Appendix A BW Policy Assessment Note

POLICY ASSESSMENT NOTE: NORTH/SOUTH SHARED PEDESTRIAN CYCLE ROUTE**53-55 VASTERN ROAD, READING (RBC PLANNING APPLICATION REFERENCE 200188)****1. Introduction**

This document has been produced in response to the comments received on 22 October 2020 from Darren Cook, Transport and Development Control Manager, and Mark Worringham, Area Planning Team Leader.

Figure 1.11
Reduction in Development

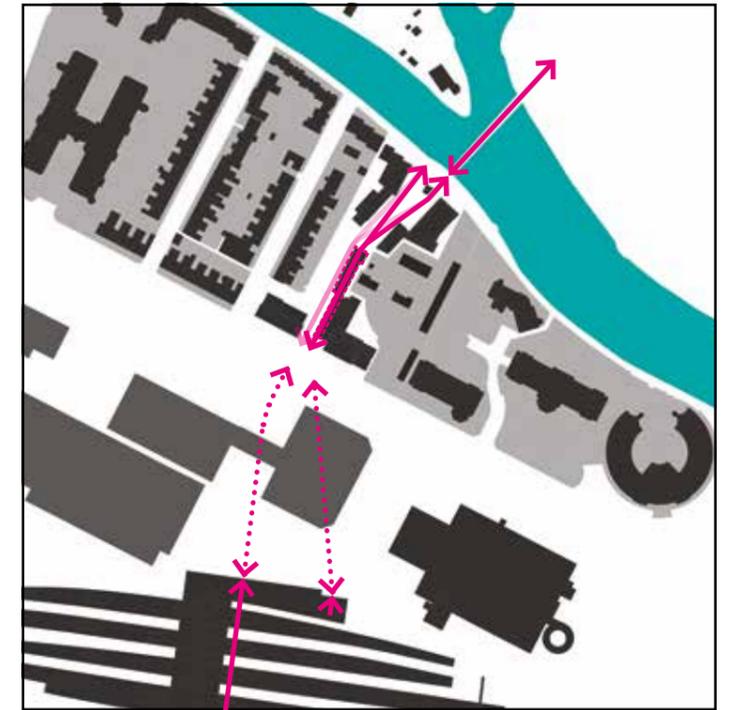
Of the feedback given to date, it was suggested within the response from Mark Worringham that the "main problem" with the directness is "the presence of the 'Goods Office' plot" and that "the extent of the Goods Warehouse also accentuates this issue".

As demonstrated within this figure, the loss of the Goods Office, and reduction of the Goods Warehouse buildings still result in a curve to the route and very little change to its connection to Vastern Road, perhaps only moving the route by ca. 3m.

This would also result in a loss of 20-21 dwellings.

Figure 1.12
Maintaining a Route to the
Station and Bridge

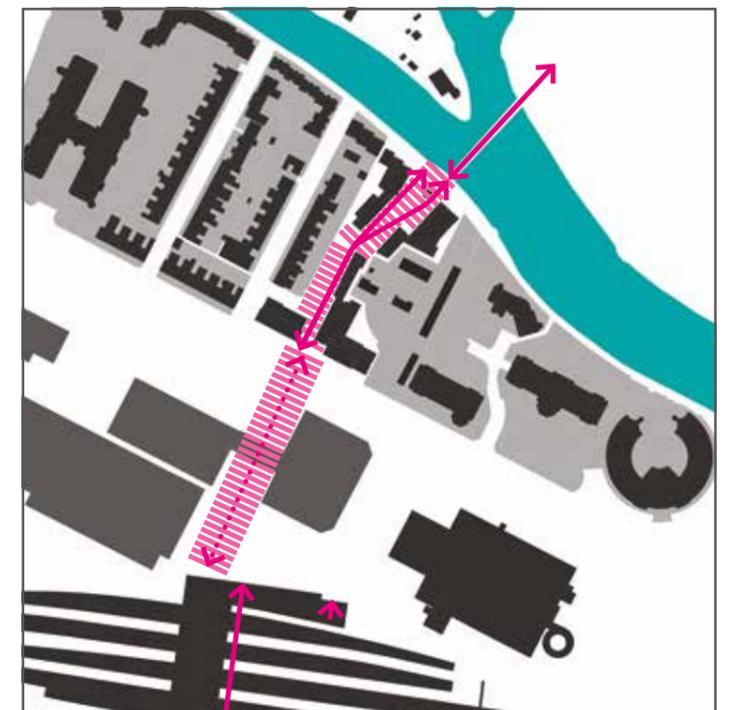
The quality and width of the route has been questioned within the site, referencing pedestrianised town centre streets of 4m wide with Chain Street being only 2.7m wide at the approach.

Our proposal is a much wider street than the ones referenced, being 15-16m wide through the middle of the site, with a local narrowing to 9m towards Vastern Road, but opening out to 25m+ towards the River Thames.

The proposed foot / cycleway within these "streets" varies, but is no less than 3m wide on the route to and from the Bridge, in accordance with LTN 1/20 July 2020.

Figure 1.13
Submitted Scheme

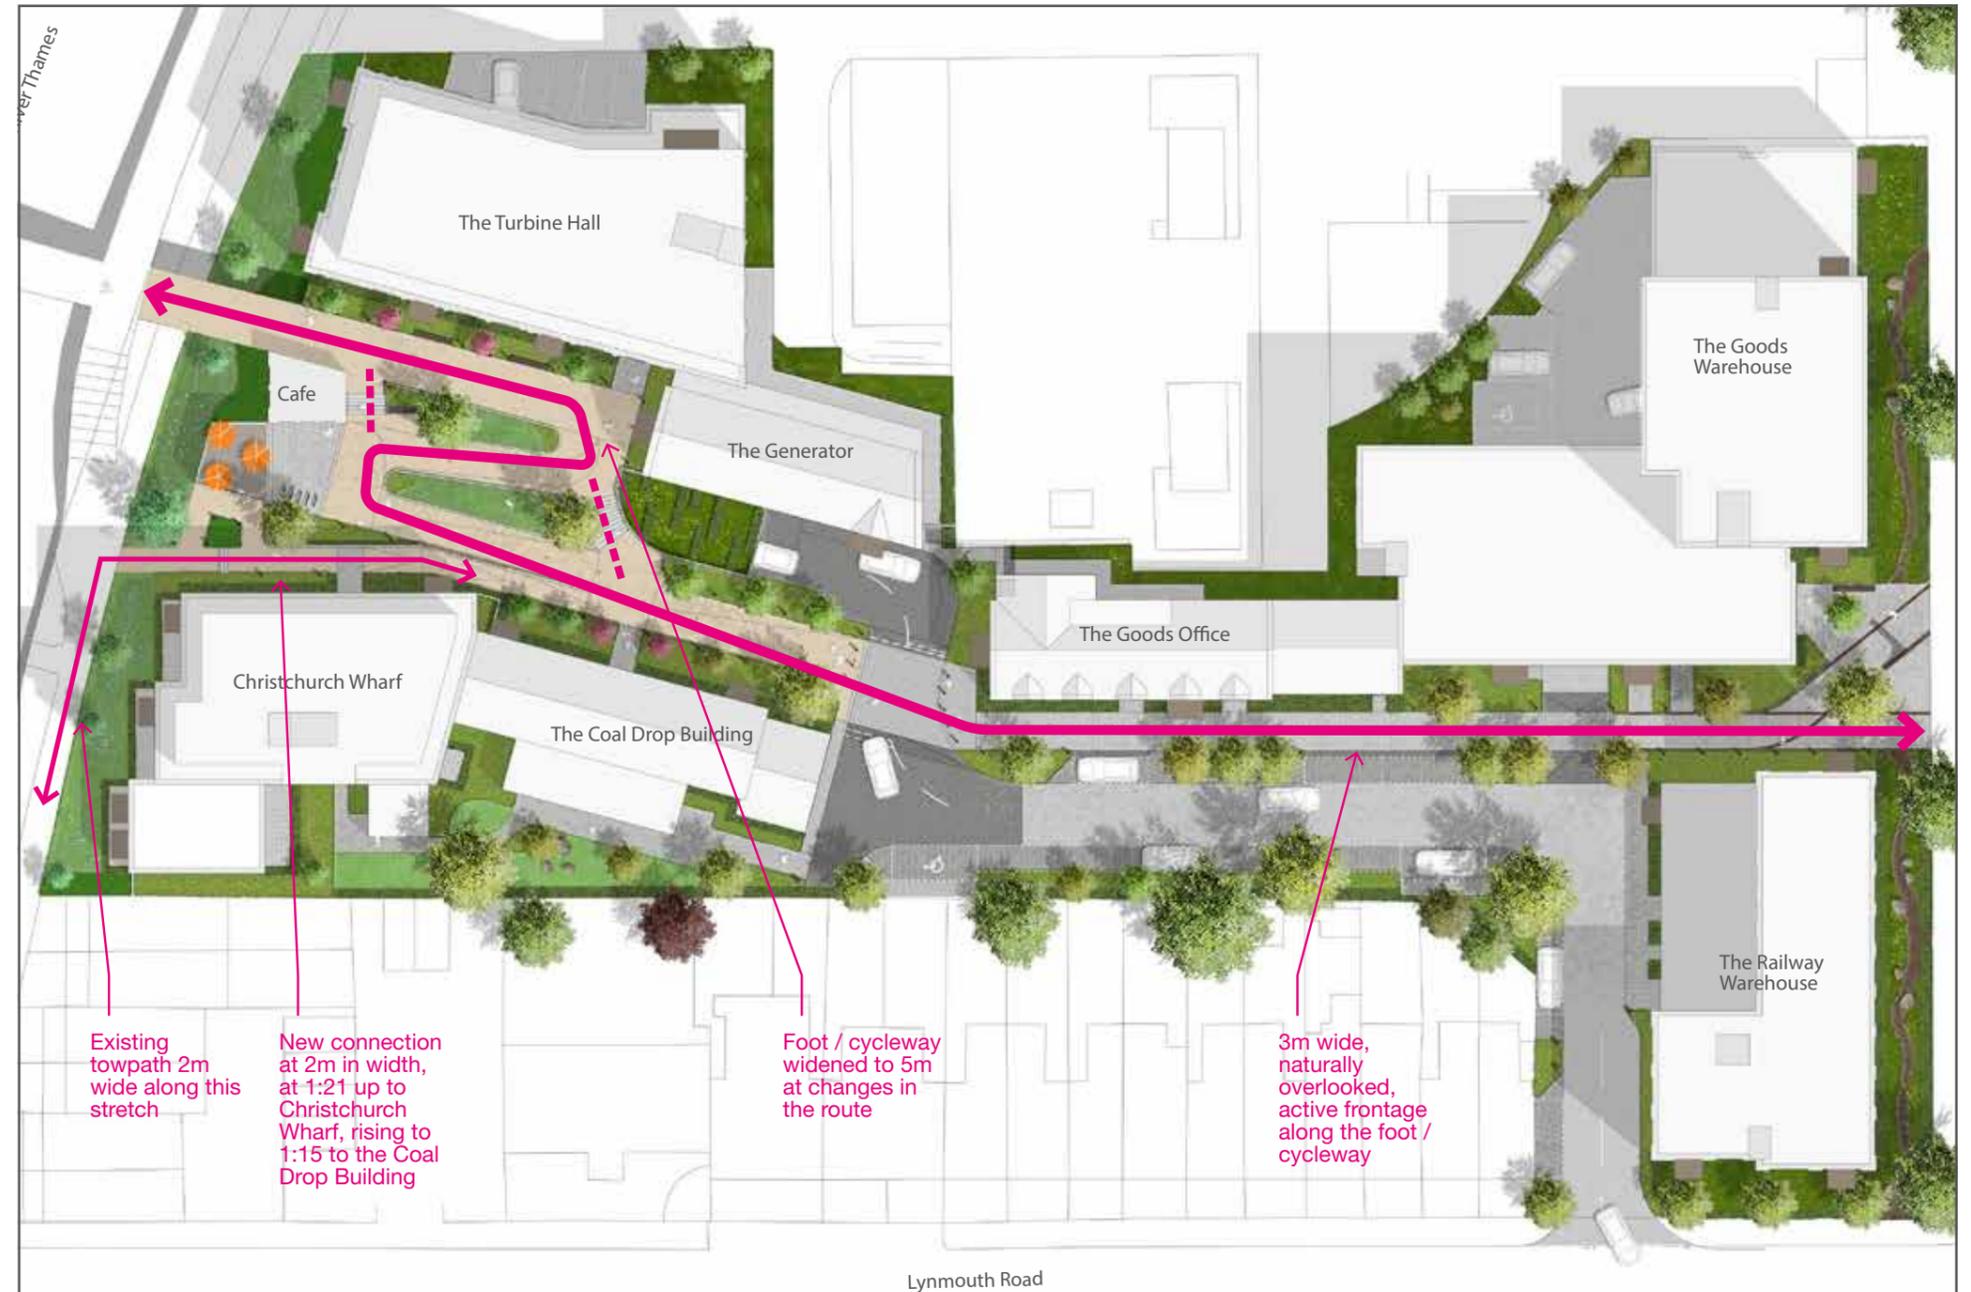
In the correspondence received on 22 October 2020, the widths of the proposed foot / cycleway through the site have been questioned and suggested that they are not wide enough.

On the main route to and from the Bridge, as noted in figure 1.12 above, the foot / cycleway as proposed through the scheme is 3m in width as a minimum, increasing to 4m to the connection on to Christchurch Bridge and on changes in direction.

- the foot / cycleway is designed to deliver a direct route to and from Christchurch Bridge, taking in to consideration site constraints, and at a width accepted during pre-application advice stage,
- the connection to the Towpath is at the same width as the towpath itself, with gradients in accordance with Building Regulations,
- high quality tree planting and other soft landscaping follow the route through the site,
- dwellings face the route throughout, providing natural surveillance and overlooking.

Figure 1.14
Alternate Route Option 1 -
Descend from Bridge

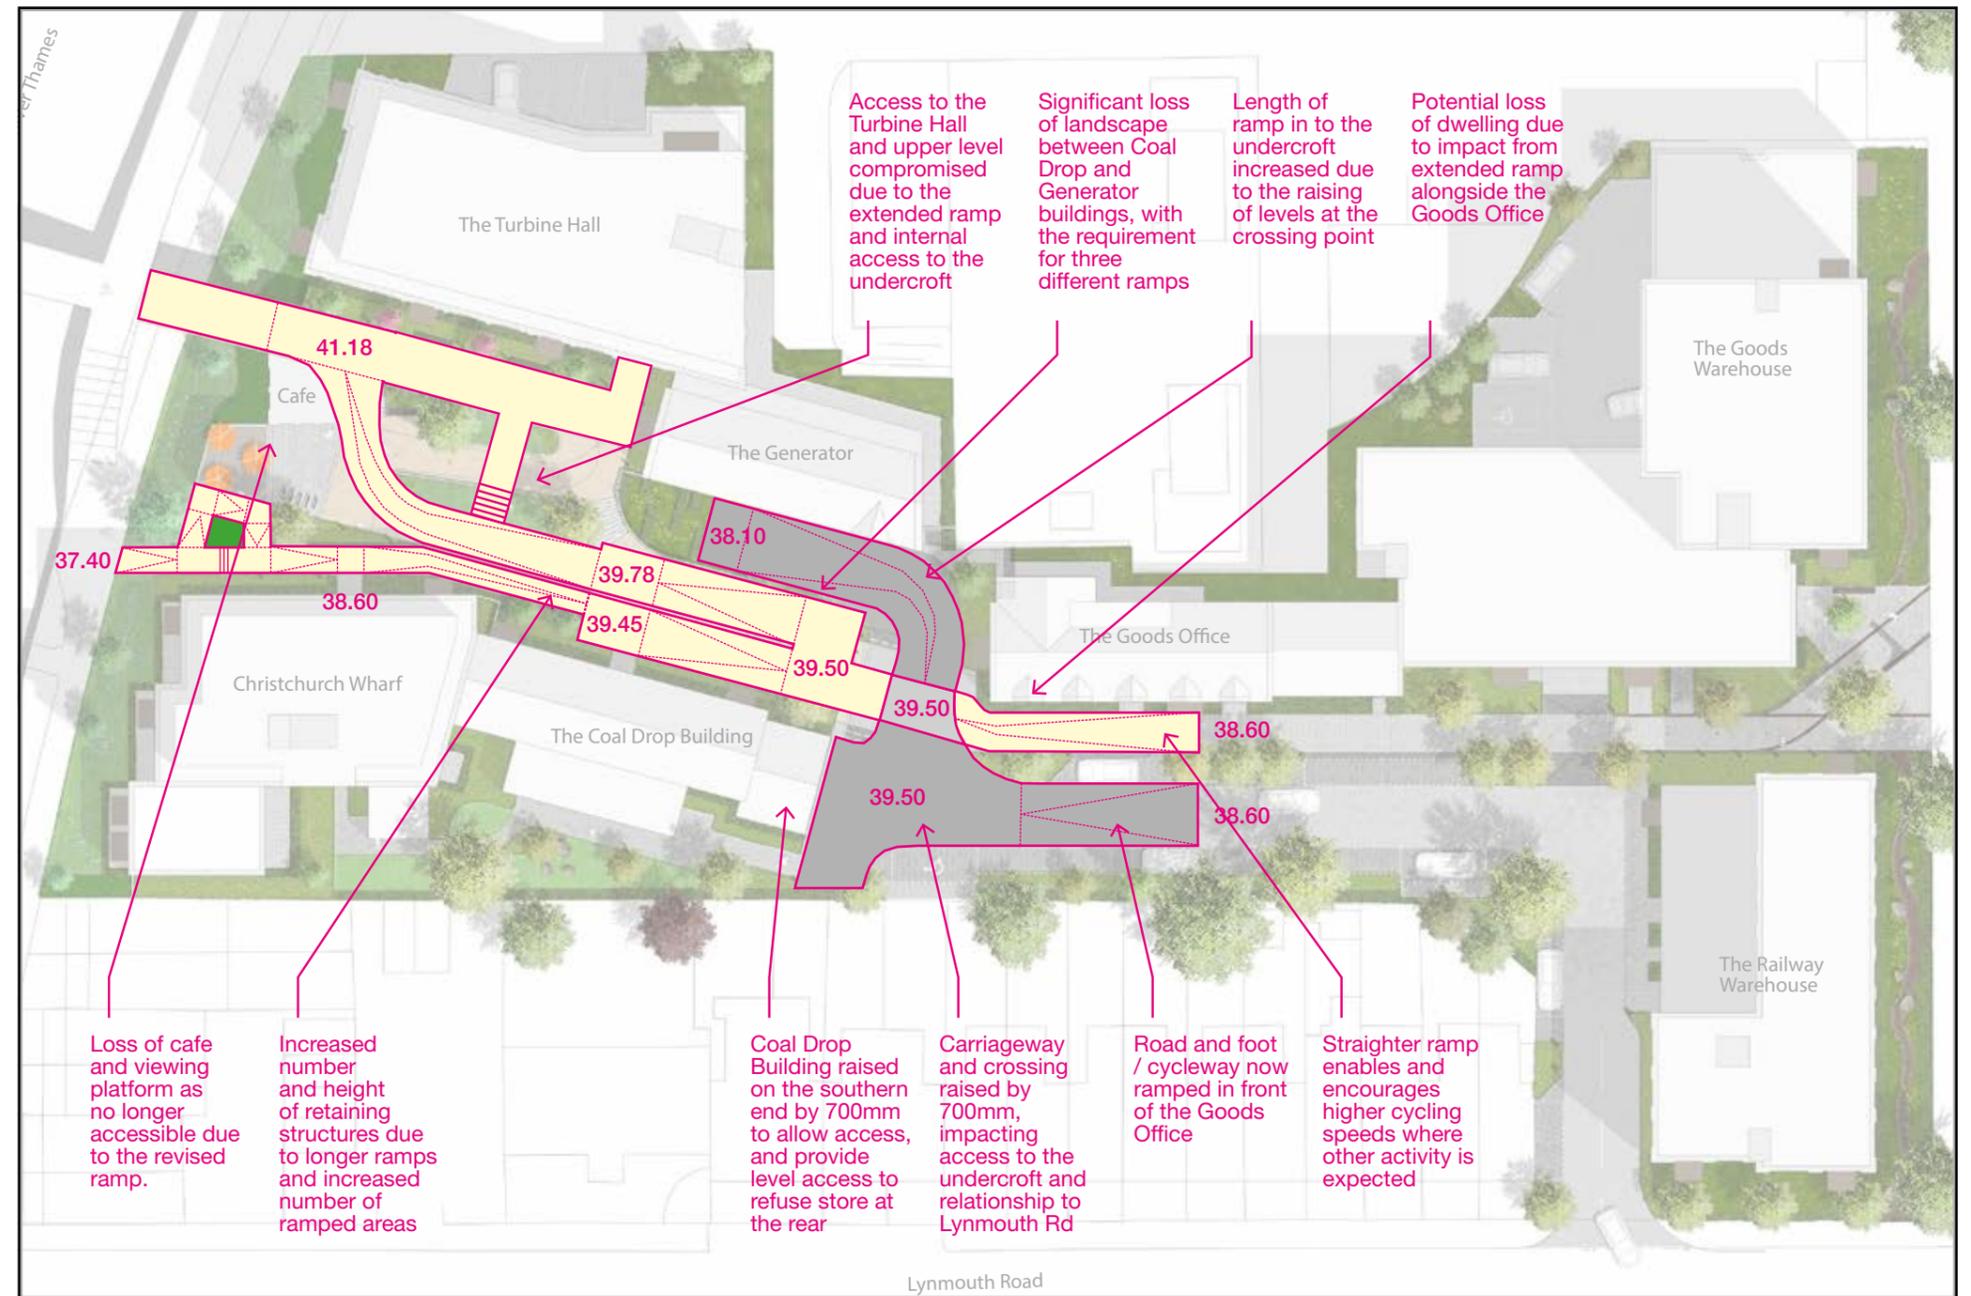
Finally, to address the comments in relation to exploring a straighter route, as demonstrated on the previous figures this is not achievable due to the retention of the SSE equipment.

However, in order to assess the impact on the development an illustrative scheme is set out below which removes the "switchbacks". For the purpose of this diagram, it is assumed that the response in figure 1.13 is accepted in relation to the width of the ramp to the towpath.

In summary, removing the gentle bends to provide a "straighter" route impacts the proposals as follows;

- as the ramp is straightened, the ramp would then extend further towards Vastern Road,
- the carriageway and crossing would raise by 700mm impacting on the relationship with Lynmouth Road gardens, as well as requiring the Coal Drop Building and Goods Office to be raised by the same amount,
- the direct ramp would result in the loss of the Cafe, viewing deck, and usable soft landscaped areas,
- the point at which the Towpath connection meets the Bridge route would also move further south, resulting in little to no soft landscape between the Coal Drop Building and Generator
- straight ramp enables and encourages higher cycling speeds creating conflict.

Figure 1.15
Alternate Route Option 2 –
Descend from Crossing

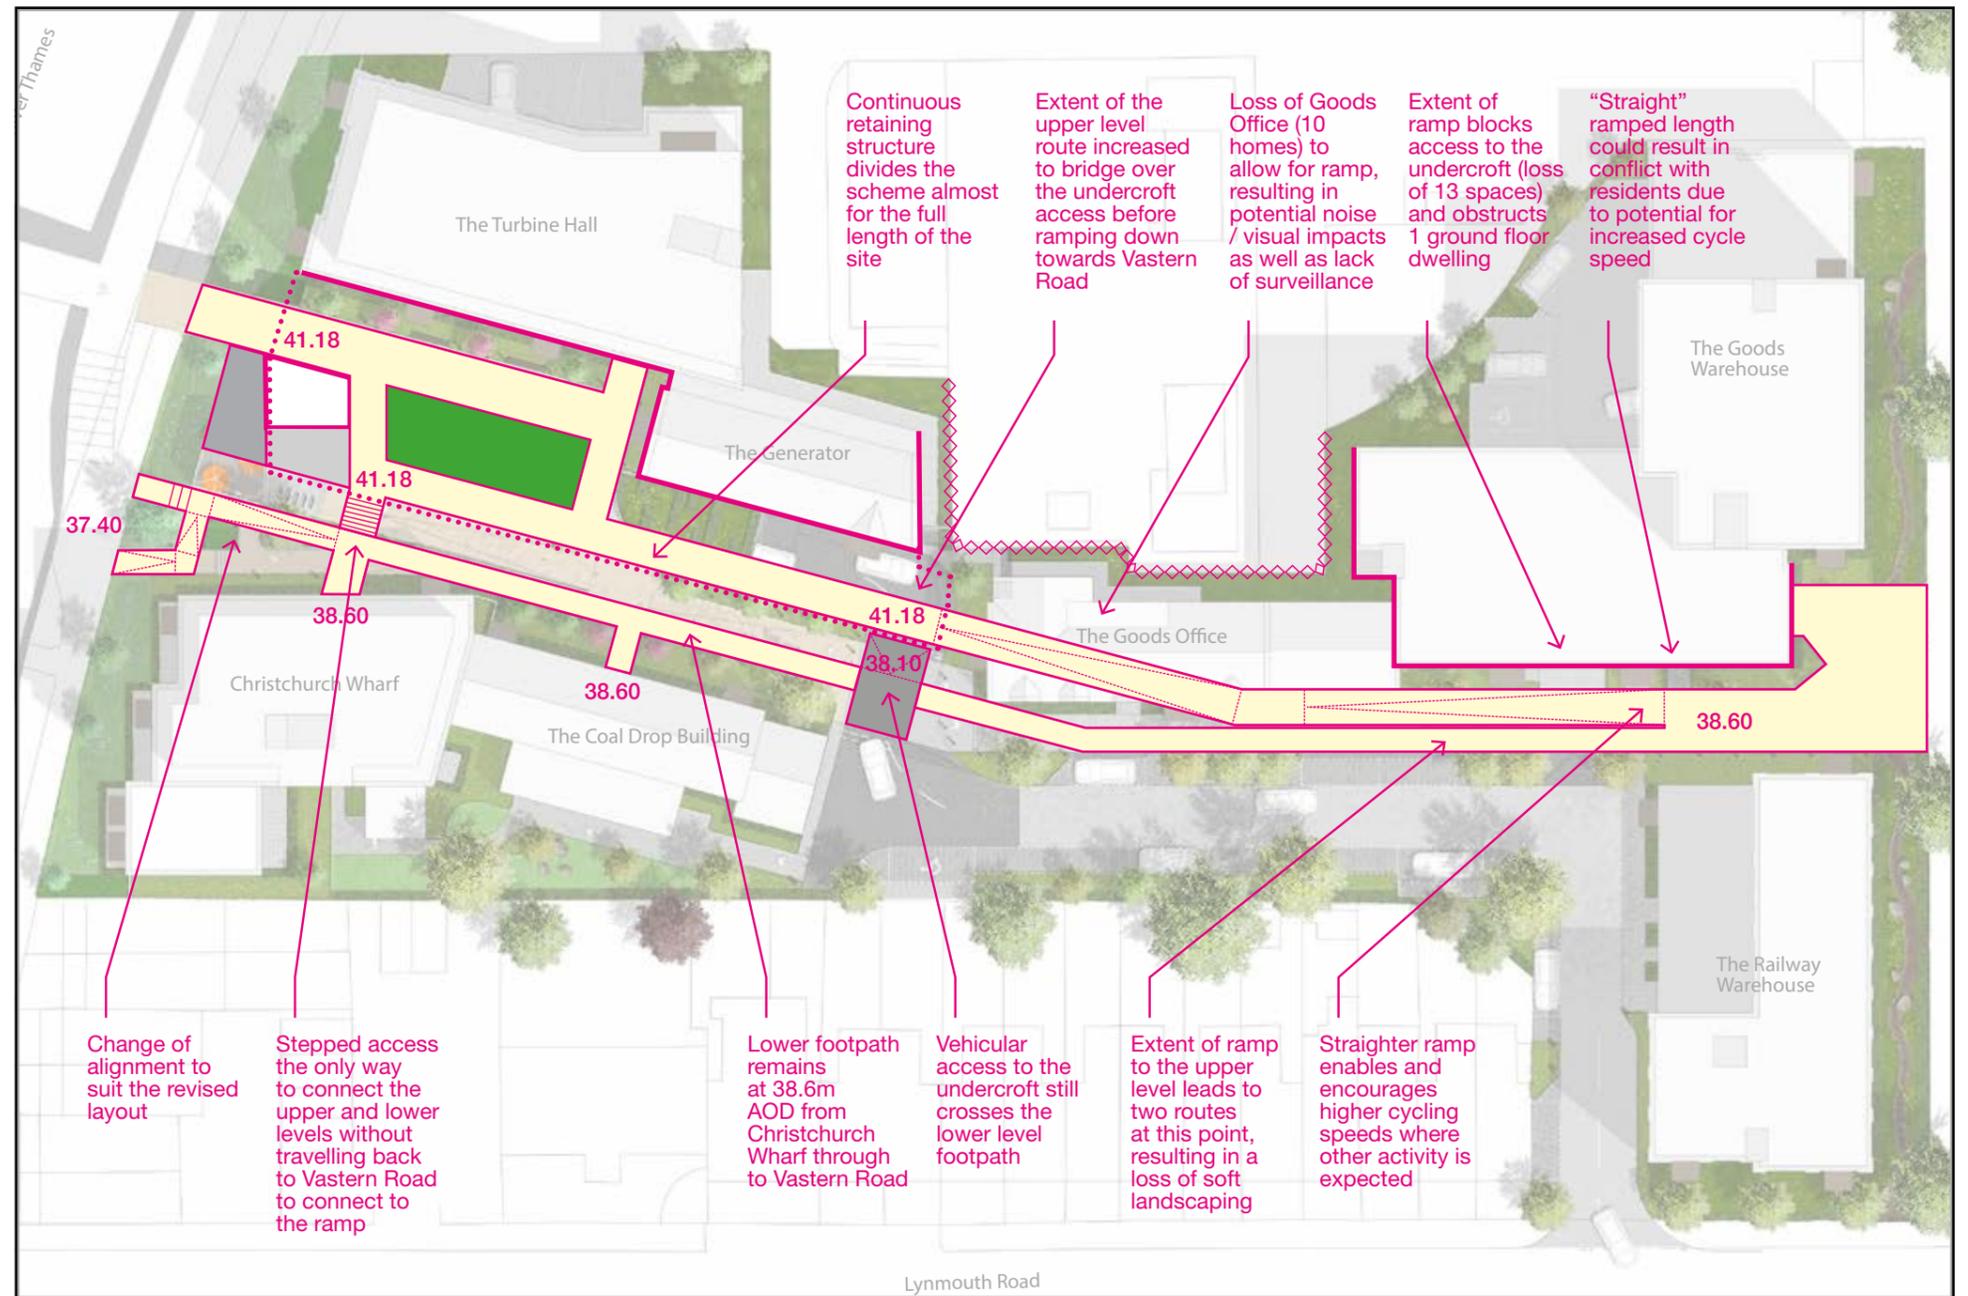
As an alternate option, a more linear route has also been investigated as follows. For the purpose of this sketch, it is assumed the Towpath connection is 2m and the Bridge connection is 3m.

In this scenario the whole of the ground floor of Christchurch Wharf and Coal Drop Building would be facing on to a 3.7m high structure which would support the foot / cycleway, under which would be the undercroft.

An engineered fire solution would be required as a fire appliance would not be able

to access the Turbine Hall and Generator buildings. The Goods Office would need to be removed, resulting in a loss of 10 homes. Access to the undercroft on the Goods Warehouse would be blocked by the ramp, resulting in a loss of 13 parking spaces. This would also require the loss of 1 more home due to the ramp. A revised refuse strategy would also be required for this building. With no building to screen the SSE equipment, views and noise would then become an issue.
